CHAPTER 4

REVISIONS TO THE DRAFT EIR

In accordance with Section 15132(e) of the CEQA Guidelines, this chapter summarizes revisions made to the Draft EIR resulting from the response to comments (see Chapter 3). The changes are presented by page number in each chapter that appears in the Draft EIR. The full text of the revised Table 2-1 of the Draft EIR, which summarizes impacts, control measures, and mitigation measures, is included in Chapter 2 of this Responses to Comments Document. Revised or new appendix material is included at the end of this report.

- Page 13-46. Subsection 4 is modified as follows:

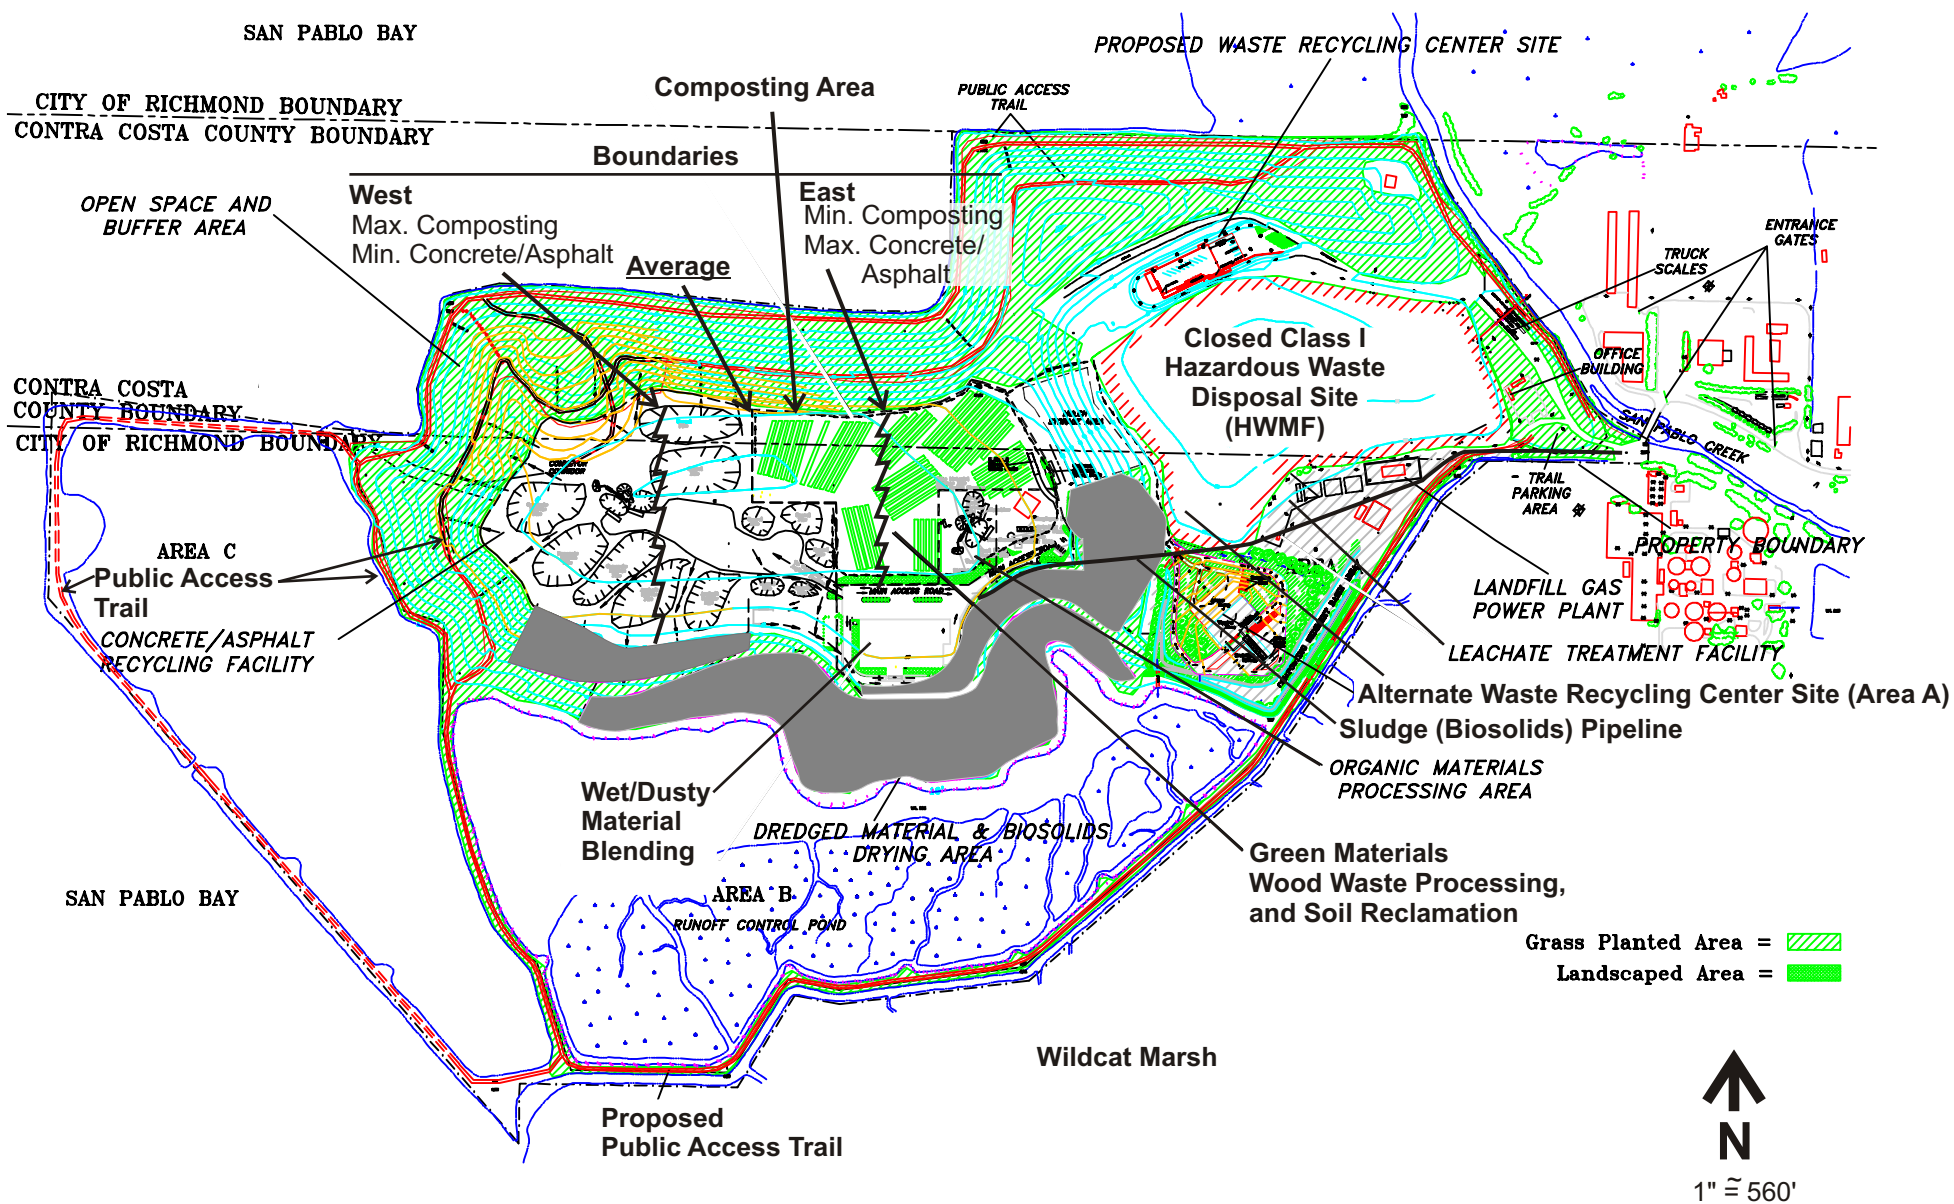
4. Public Access Trail

A key recommended mitigation measure in Chapter 9, Biological Resources, is the elimination of the Phase 4 alignment of the Trail **and the proposed Phase 1 Trail improvements from the southern end of the mainland levee along the west side of Area C to the first breach in the outer levee.** The Phase 4 alignment **These segments of the Trail** would loop around WCCSL Area C. Because the levee around Area C has been breached to allow for tidal action, two pedestrian bridges would need to be constructed. Chapter 9 **This EIR** recommended Mitigation Measure 9-4(a) to eliminate Phase 4 **and this Phase 1 segment** because the levee provides important resting, roosting, and nesting habitat for birds. Human access associated with the Phase 4 **these segments of the Trail** alignment would greatly diminish and possibly eliminate the use of this area by many species. Thus, the PEA includes Phases 1 **(as modified)**, 2, and 3 of the Trail as described in Chapter 3.

Figure 3-7 Proposed Public Access Plan Conceptual Design (Revised)

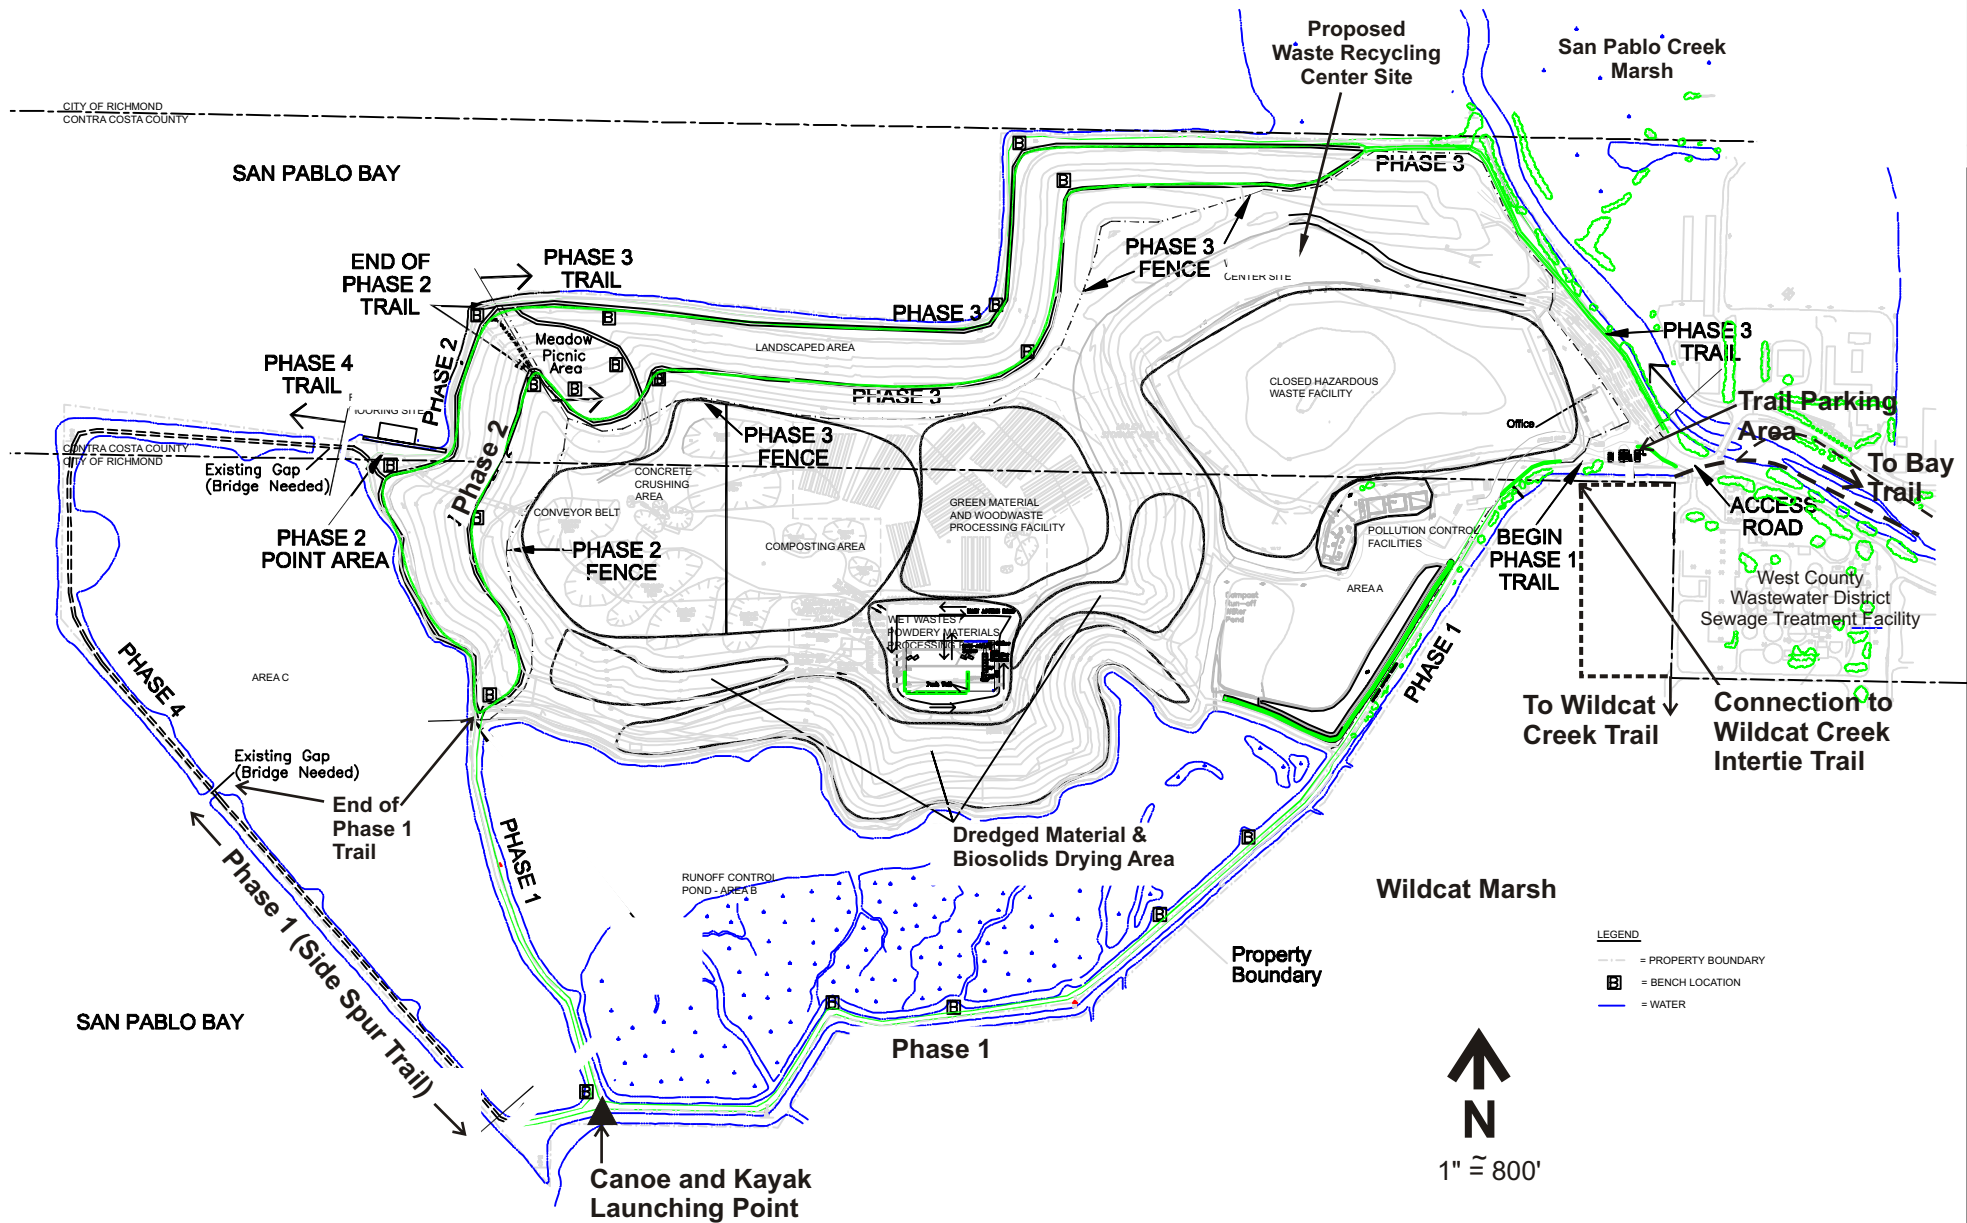
- Page 2-11. The first sentence of the third paragraph is modified as follows:
 “. . . The Preferred Environmental Alternative . . . includes . . . elimination of Phase 4 of the Trail **including the proposed levee along the west side of Area C to the first breach in the outer levee,** the Area A location . . .”

- Page 2-29. Mitigation Measure 9-4(a) is modified as follows:
 “a) The Phase 4 alignment of the Trail would be eliminated from the proposed Project to avoid the ~~require~~ **resulting** disturbance to shoreline habitat on this portion of the site and prevent the potential disruption to wildlife habitat and movement along the existing isolated levee segment. **The proposed Phase 1 Trail improvements from the southern end of the mainland levee along the west side of Area C to the first breach in the outer levee would also be eliminated from the proposed Project, serving to minimize potential disturbance to approximately half of the open water and mudflat habitat in Area C. Split rail fending or similar barrier would be installed within 10 yards of the point where the levee narrows north of the proposed kayak staging area.**”

Figure 5-3 Location of Slope Stability Cross Sections (Revised)

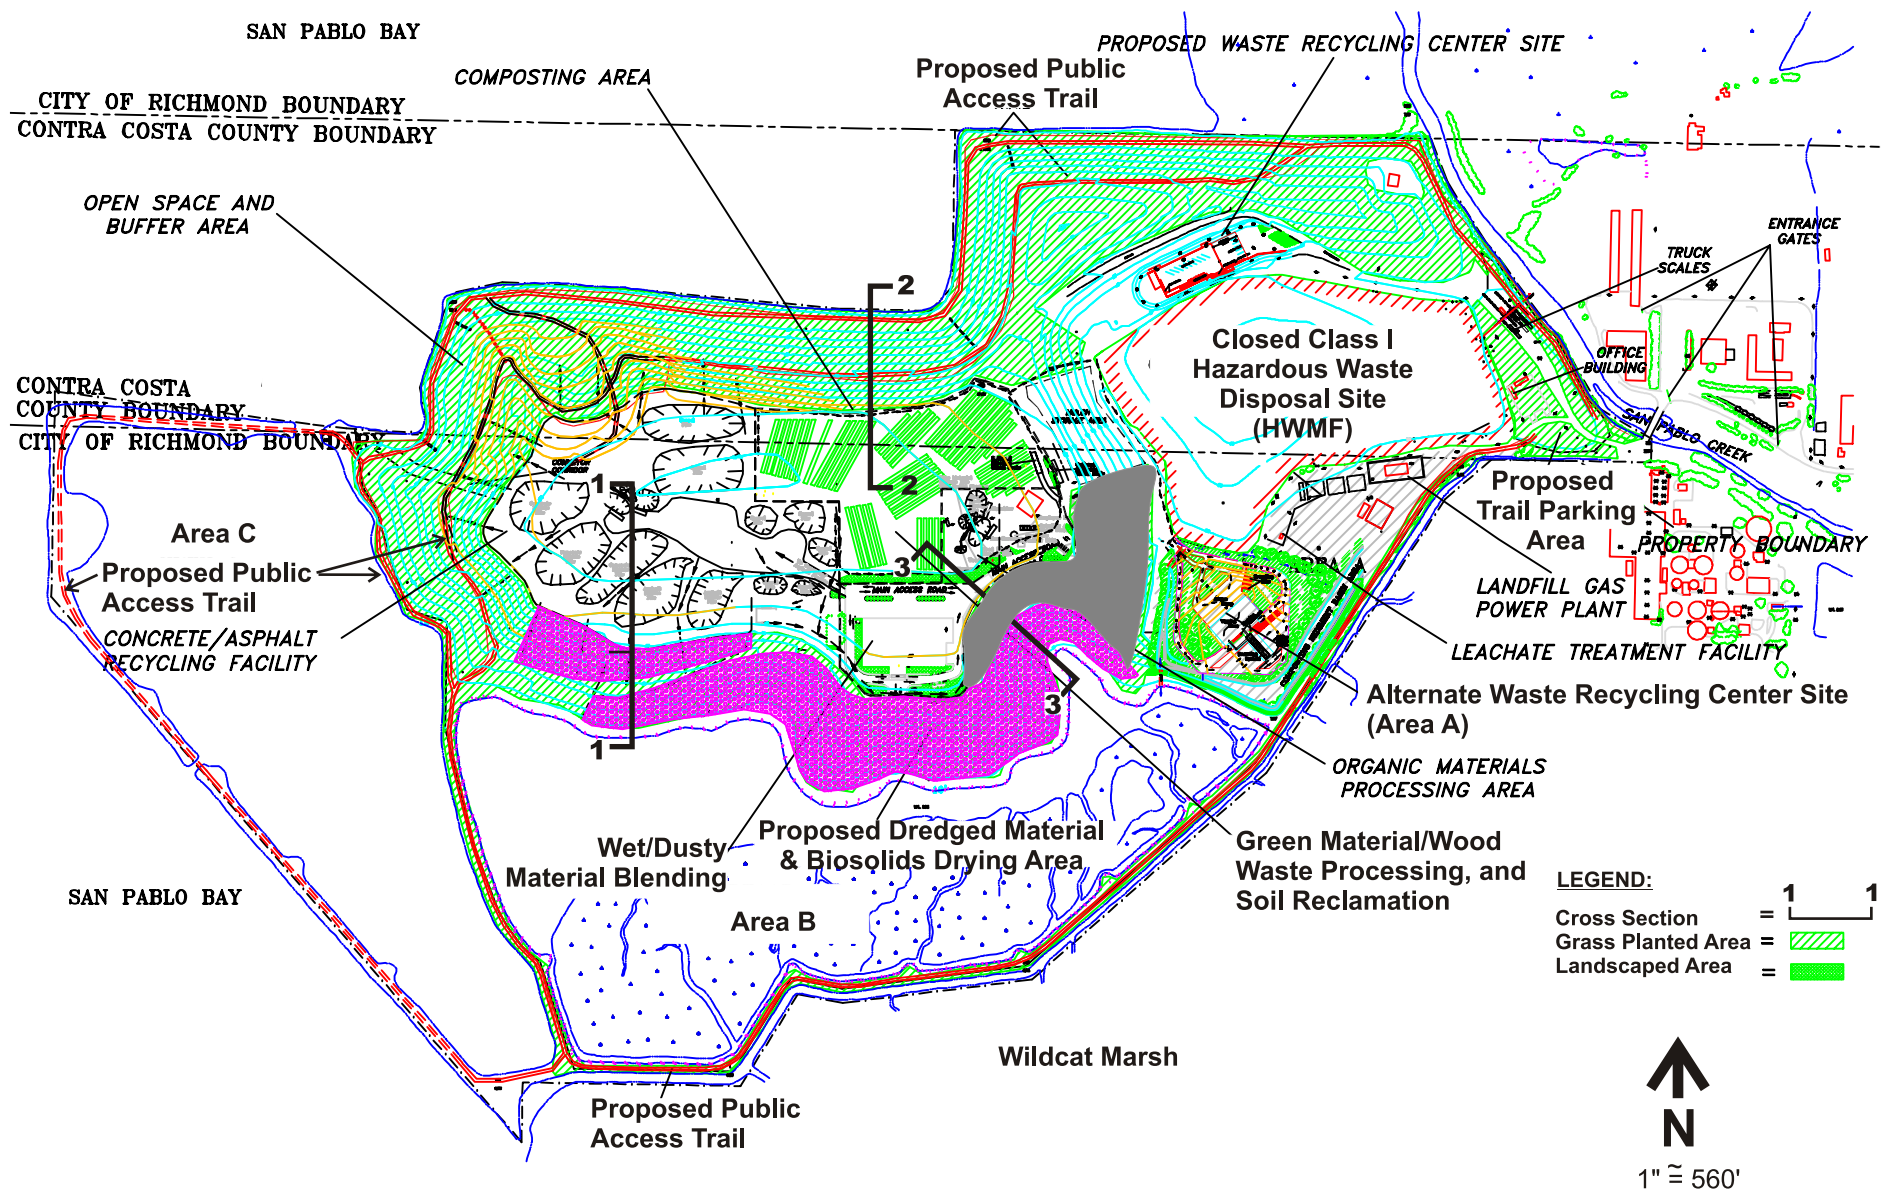
“This analysis was conducted pursuant to RWQCB Order No. R2-2001-0066 and the peer review of the analysis as required by the Order ~~is ongoing~~ **was completed in May 2003 and concurred with the analysis results.**”
- Page 5-25. Figure 5-3 has been modified to show the correct location of Section 1-1 and is included at the end of this chapter.

Figure 7A. Sideslope Areas Prior to Biosolids Application in March 2003 (New)

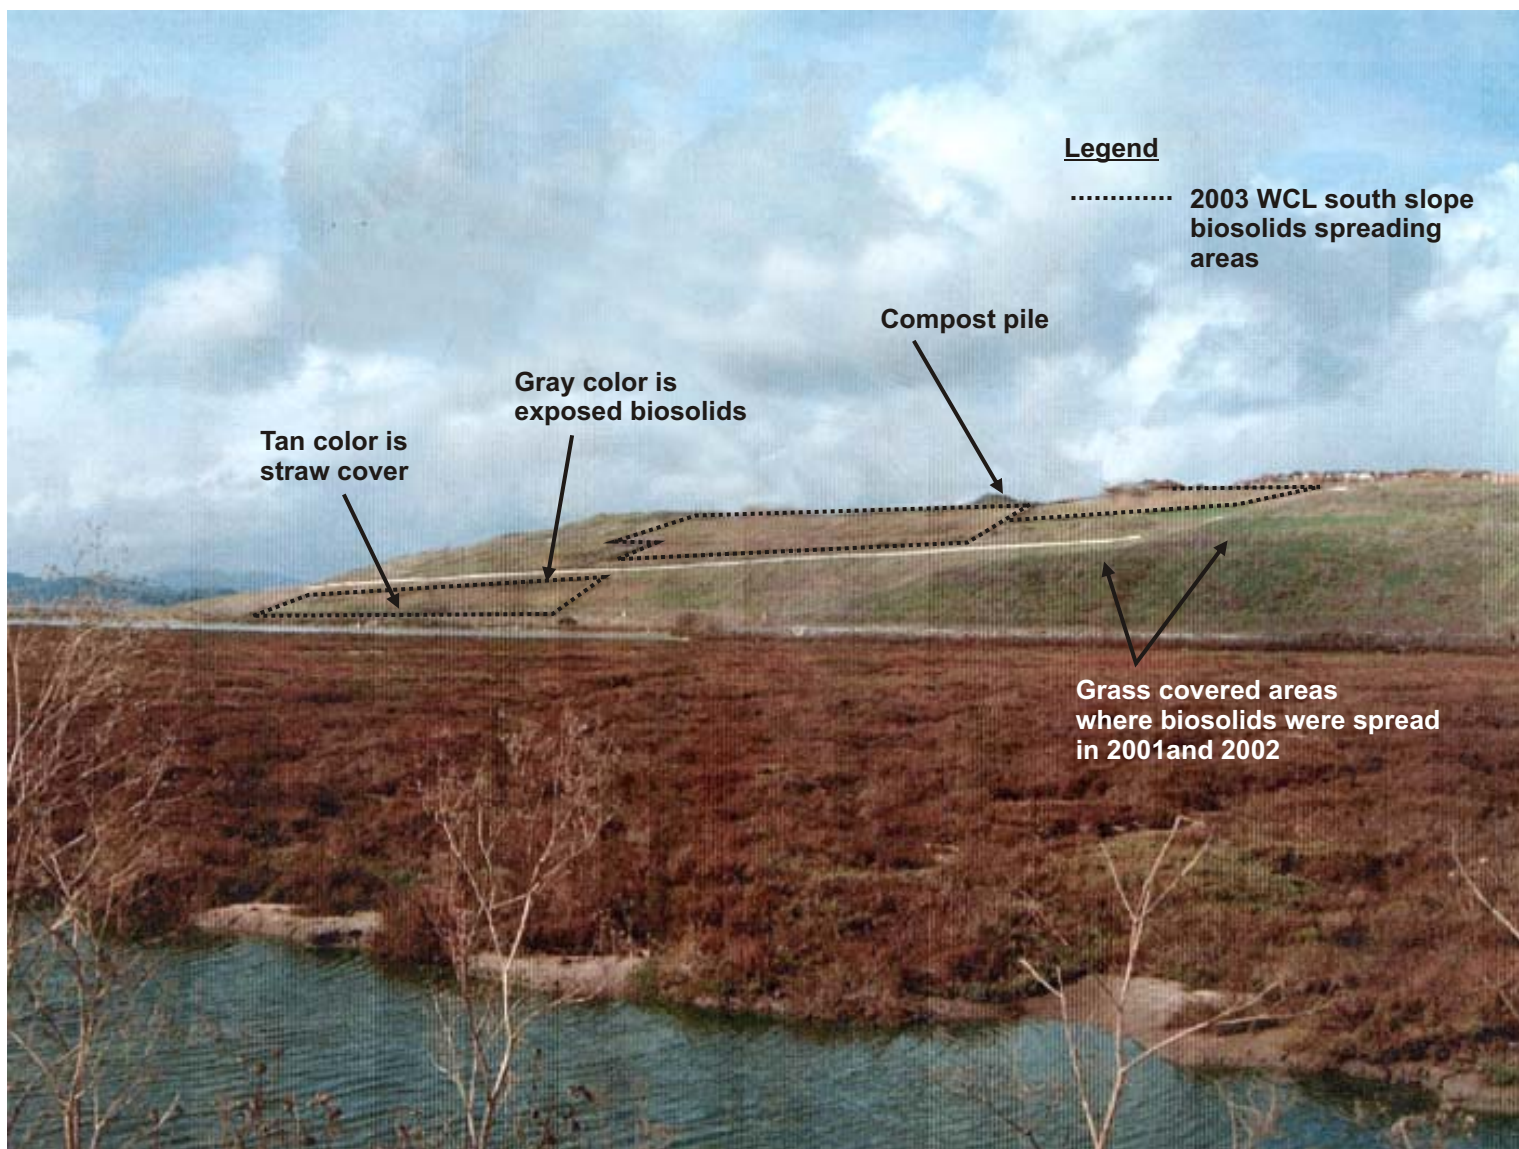
- Page 7-16. The following paragraphs have been added to the bottom of the page. Figures 7A and 7B are included at the end of this chapter.

“The spreading and drying of biosolids and dredged materials on the landfill sideslopes would also not create a significant adverse aesthetic impact. Photographs provided by the Applicant are included as Figures 7A and 7B which illustrate the visual aspects of biosolids application on the sideslopes based on actual operation experience in 2003. The photographs were taken from the Phase 1 Trail alignment and view the southern slope of the landfill.

Figure 7A is a view of the sideslope which shows grass-covered areas where biosolids were spread in 2001 and 2002 and barren areas which had not yet received 2003 biosolids applications and which were infertile. The barren areas shown would be typical of the areas of the southern slope that would receive biosolids/dredged materials. In the proposed Project, the spreading and drying operation would start in April and the other grass-covered slopes would soon begin to dry out and the grass color would change to gray and brown.
